Access Compliance Report

Public Rights-of-Way

Intersection ID: 6231	Main Street: CLEAR_SPRINGS_CT	Cross Street: COTTONWOOD_PARK_DR	Location: W
ADA ID: E57CD71BE2E9	Ramp Type: Perp	Initial Pass/Fail: Fail	Overall Compliance: No
Severity Score: 33.75			
Codes/Mitigation Info/Possible Solution		Field Measurements/Component Compliance

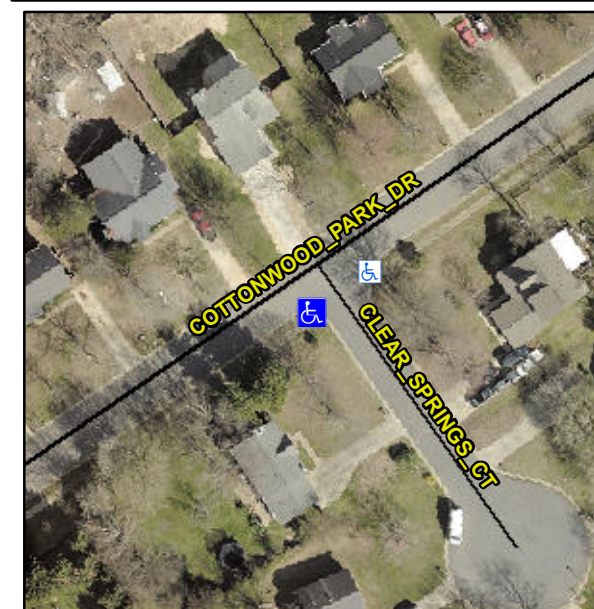
Not Found, R304.5.1, R304.5.3

Compliance	Description	Data	Compliance	Description	Data
N/A	Ramp Length (in)	46.0	Yes	Ramp Slope (%)	8.1
No	Ramp Width (in)	42.0	No	Ramp XSlope (%)	9.0
N/A	Flare Type LT	N/A	N/A	Flare Type RT	N/A
N/A	Flare Slope LT (%)	N/A	N/A	Flare Slope RT (%)	N/A
N/A	Flare Traversable LT?	N/A	N/A	Flare Traversable RT?	N/A
N/A	Landing Length (in)	N/A	N/A	DWS Provided?	N/A
N/A	Landing Width (in)	N/A	N/A	DWS Contrast?	N/A
N/A	Landing Slope (%)	N/A	N/A	DWS Length (in)	N/A
N/A	Landing X Slope (%)	N/A	N/A	DWS Full Width?	N/A
N/A	Landing Curb? (Y/N)	N/A	N/A	DWS Offset (in)	N/A
N/A	Shared Landing?	N/A			
N/A	Gutter Ponding?	N/A	N/A	Gutter Slope (%)	N/A
N/A	Gutter Lip Ht (in)	N/A	N/A	Gutter X Slope (%)	N/A
N/A	Painted X Walk1?	No	N/A	Painted X Walk2?	N/A
	X Walk 1 Direction	To E		X Walk 2 Direction	N/A
N/A	X Walk 1 Width (in)	N/A	N/A	X Walk 2 Width (in)	N/A
	X Walk 1 Slope (%)	6.8		X Walk 2 Slope (%)	N/A
	X Walk 1 X Slope (%)	4.8		X Walk 2 X Slope (%)	N/A

Remove & Replace Entire Ramp.
